Service Update

SU2202

Cluster Software Improvement

Models Affected: Certain 2022-2023 Model Year Blue Bird Vision (BBCV) buses equipped with the new electrical architecture (NEA) or electric powertrain.

Fig 1

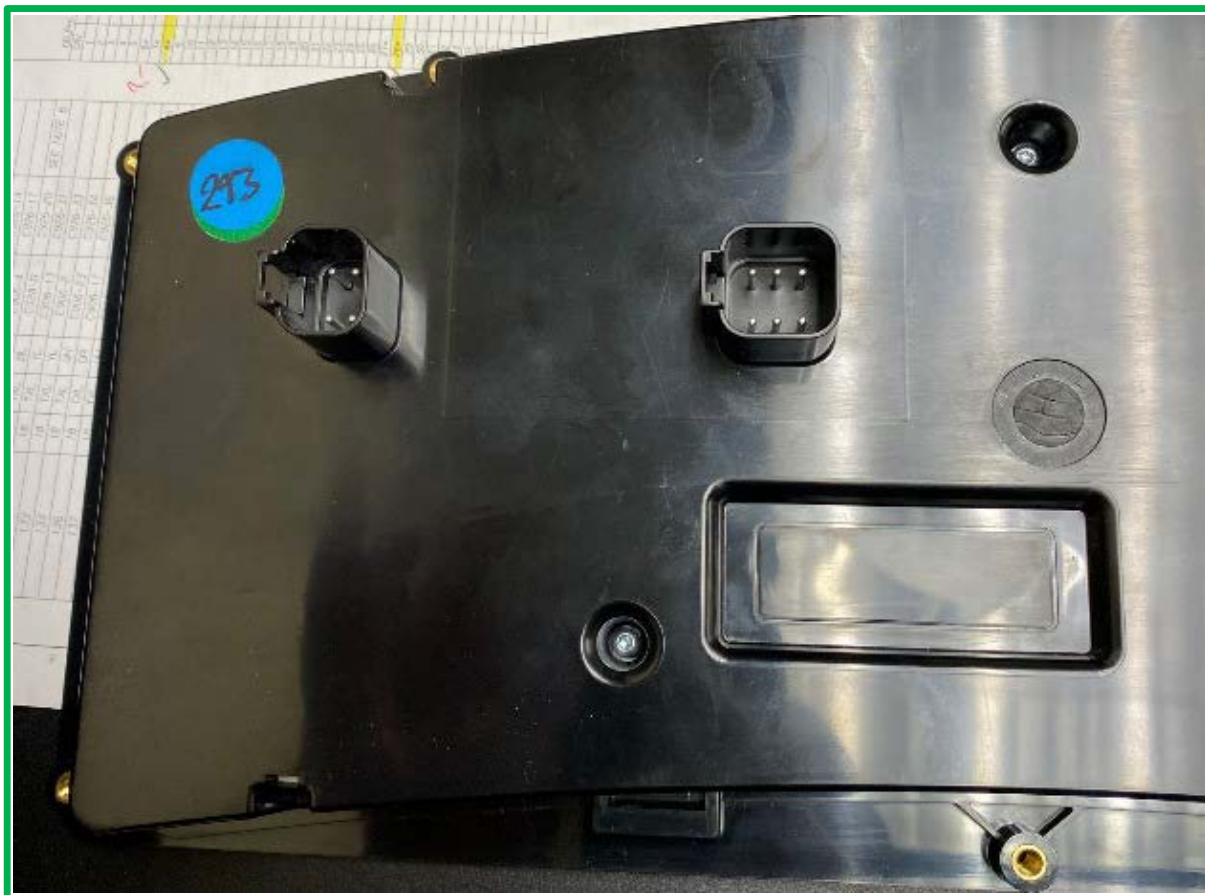
Step 1: Verify Cluster is CAN based. See Fig 1 & 2

Figure 3

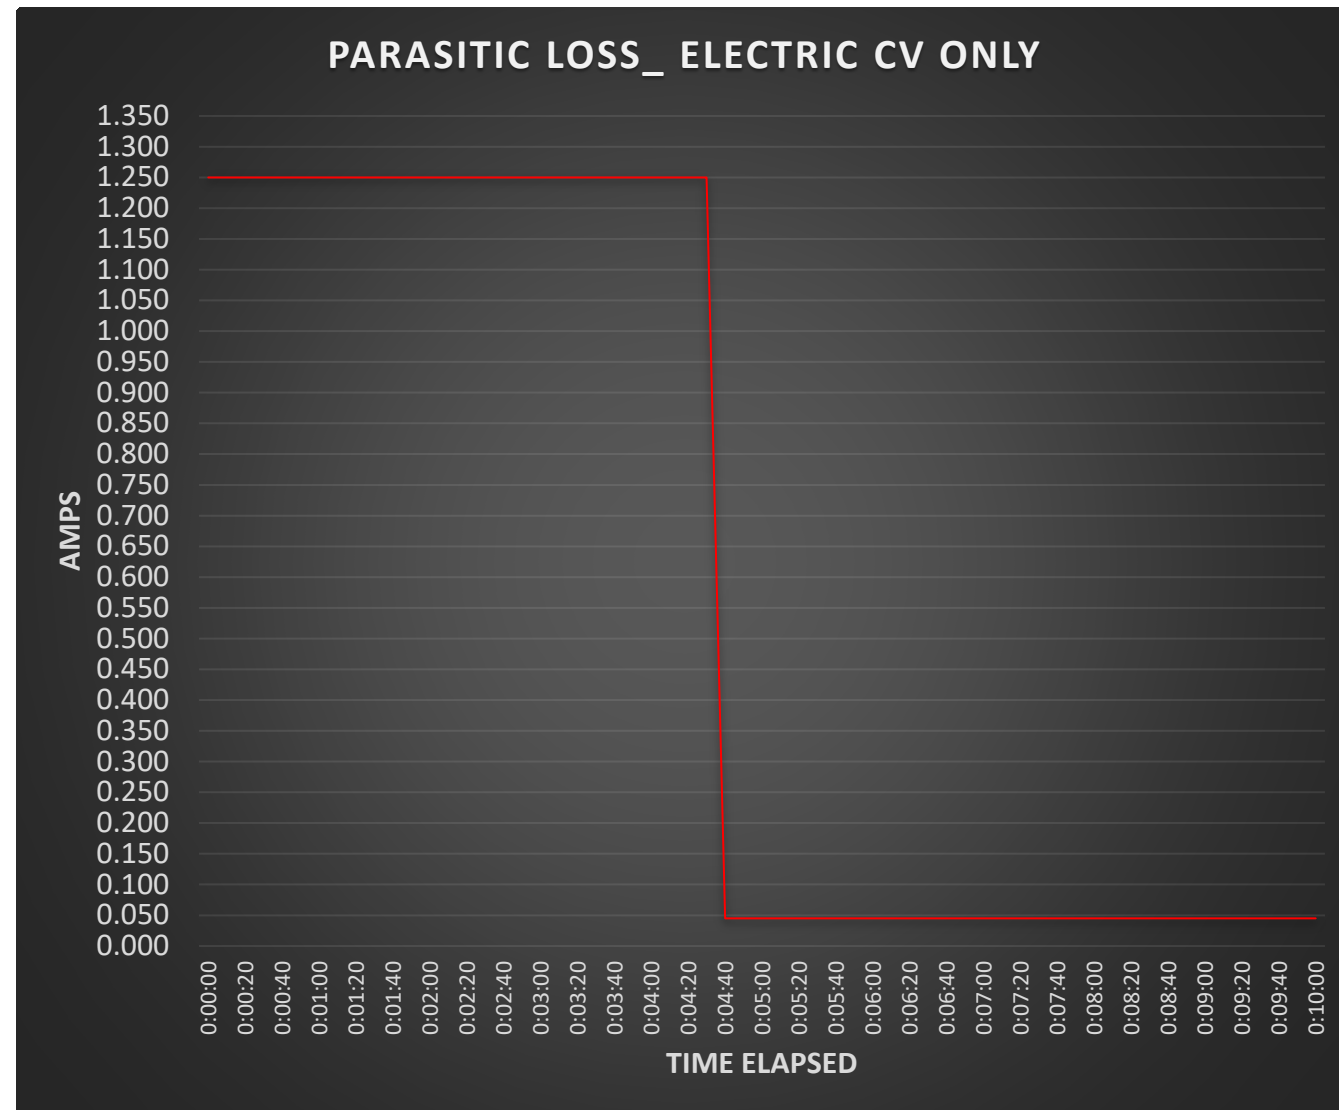
Step 5: Measure parasitic battery loss per Fig 5/6. Verify measured value is within 5% of Fig 3/4. If outside limits, enter a support ticket via vantage for field service to engage
